Project	IEEE 802.20 Working Group on Mobile Broadband Wireless Access < http://ieee802.org/20/ >	
Title	MBTDD Wideband Mode Performance Report II Errata	
Date Submitted	2006-01-12	
Source(s)	Jim Tomcik Qualcomm Incorporated 5775 Morehouse Drive San Diego, CA, 92121	Voice: 858-658-3231 Fax: 858-658-2113 Email: jtomcik@qualcomm.com
Re:	MBWA Call for Proposals	
Abstract	This contribution highlights a few errors in the MBTDD Proposal documents that were submitted on January 6. More specifically, errors noted are in MBTDD Wideband Mode Performance Report 2 (C802.20-05/88r1). This contribution is provided for the information of the 802.20 working group to clarify these materials.	
Purpose	FYI.	
Notice	This document has been prepared to assist the IEEE 802.20 Working Group. It is offered as a basis for discussion and is not binding on the contributing individual(s) or organization(s). The material in this document is subject to change in form and content after further study. The contributor(s) reserve(s) the right to add, amend or withdraw material contained herein.

MBTDD Proposal Package: Performance Report II (C802.20-05/88r1) Errors

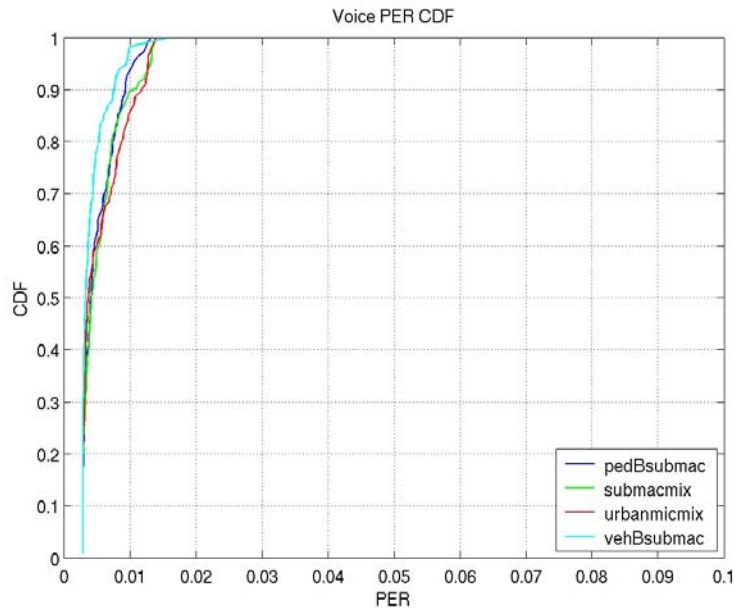
1) There is an incorrect plot in Section 1.2.1. Replace Figure 1.6 with the following:
